Wakefield St Streetscape Project

Thank you for the opportunity to comment on Adelaide City Councils proposals for the Wakefield St streetscape project. Bike Adelaide has been advocating for utility cyclists since 1974. We represent the interests of people who cycle to work, school, shops and for other daily activities. Our aim is to not only represent existing cyclists but to assist all levels of government in their aim of encouraging the significant proportion of the population who say that they would cycle if conditions were safe enough into active cyclists and protecting the safety of the cyclists who currently use our roads and other facilities. **In this second submission we seek to cover the technical aspects of our earlier submission.**

Figure 4.4: Typical bicycle/car parking lanes layout (parallel parking)

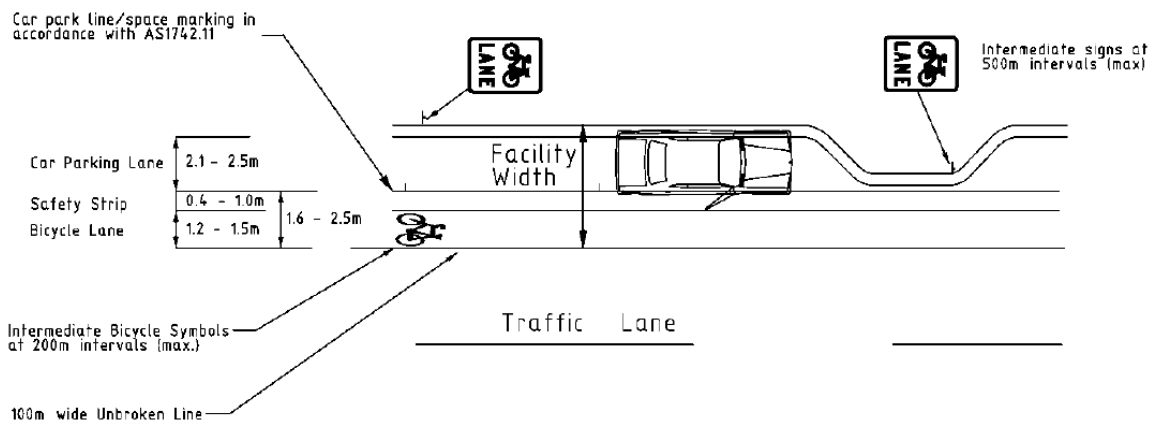
We note that the proposal does not indicate inclusion of clearance (or safety strip) between the bike lane and parallel parking. The safety strip is a zone that allows for car door to open without impinging on the bike lane. For on-street bike lanes adjacent to kerbside parking, good practice is to mark the safety strip adjacent to parking, to encourage cyclists to avoid this area; as per Figure 4.4 of Austroads' Cycling Aspects of Austroads Guides (AP-G88-17), reproduced below.

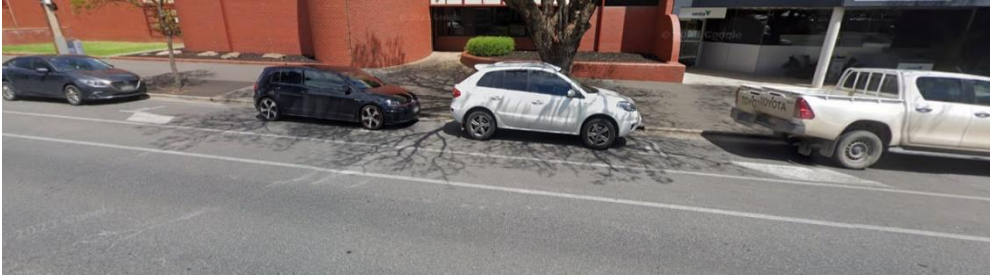
Figure 4.5 of AP-G88-17 shows safety strip marking on both sides of the bike lane; an excerpt is shown below, illustrating one means of marking the safety strip between parked cars and the bike lane proper:

The advice provided by Austroads with Figure 4.5 is that “Where sufficient width is available within a carriageway it is desirable to provide a safety strip between the traffic lane and bicycle lane as shown in Figure 4.5.”

The proposed bike lane widening fails to respond to this Austroads guidance. Instead of using the generous carriageway width to mark a safety strip that would improve cyclist safety by increasing separation to moving traffic, this has been allocated to parallel parking (3.8m-4m) or a median (4m), neither of which will improve safety for any road users with the existing safety strip marking deleted.

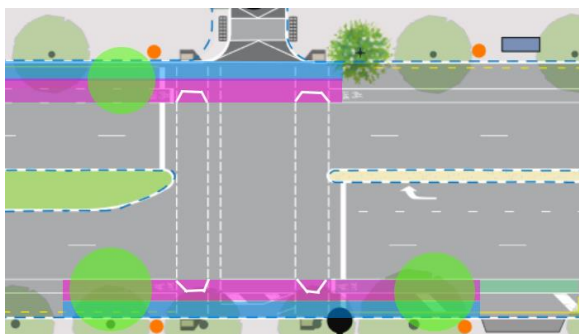
Our proposed layout needs to change near bus stops to facilitate continued bus servicing. All bus stops in this section of Wakefield Street are in locations where on-street parking is not permitted. A good option would be to provide a kerb extension for bus loading, with the bike lane continuing as a narrower (say) 1.6m bike path over the kerb extension. The bus stop/ loading area could be provided using the remaining bike lane width (1.2m) + safety strip (0.6m) + some (0.5m) to all (2.5m) of the parallel parking width, to create an area that can host a bus shelter, removing the impact of shelters on the footpath. This impact is evident in the “typical cross section”:

The narrower stop/ loading area option would, in conjunction with the wide kerbside travel lane, allow vehicles to pass a stopped bus, but creates the risk that cyclists’ view to passengers is restricted by the shelter. The wider stop/ loading area option would maintain visibility but not allow vehicles to pass a stopped bus.

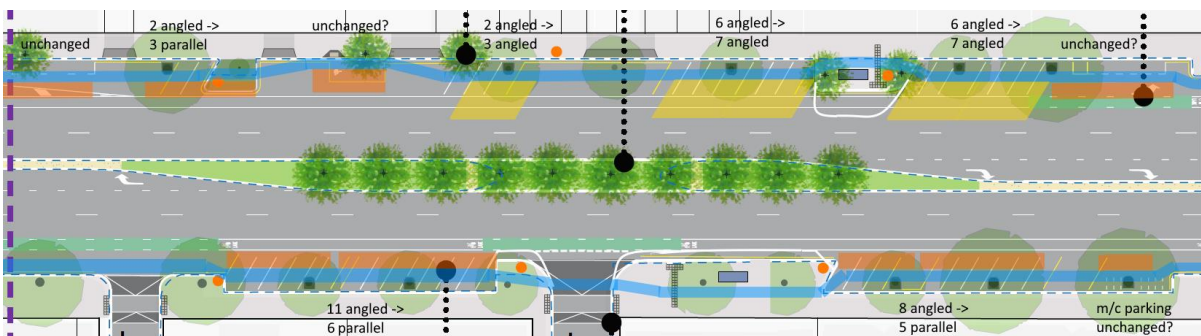
Bike Adelaide believes that separated bicycle lanes could be provided between Frome Street and Pulteney Street at a cost to car parking in the order of half a dozen spaces, by either:

- changing the angled parking on the southern side to parallel, and reallocating the remaining road space; or
- changing the angled parking on the northern side to parallel, and reallocating the remaining road space.

The surprisingly small quantum of loss in parking is due to the parallel parking being offset from the kerb, allowing this to be provided adjacent to street trees whereas angled parking can only be provided between street trees.

South side changed to parallel:

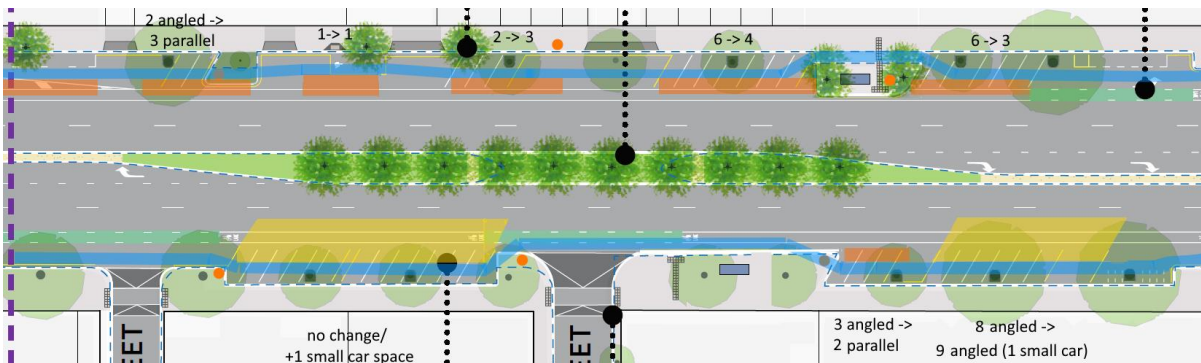
The biggest technical constraint is dealing with the bus stop adjacent to Cypress Street (or the street trees also occupying the kerb protuberance.) We believe this is manageable, but will require precise detailing in regard to the continuous footpath treatment across Cypress Street.
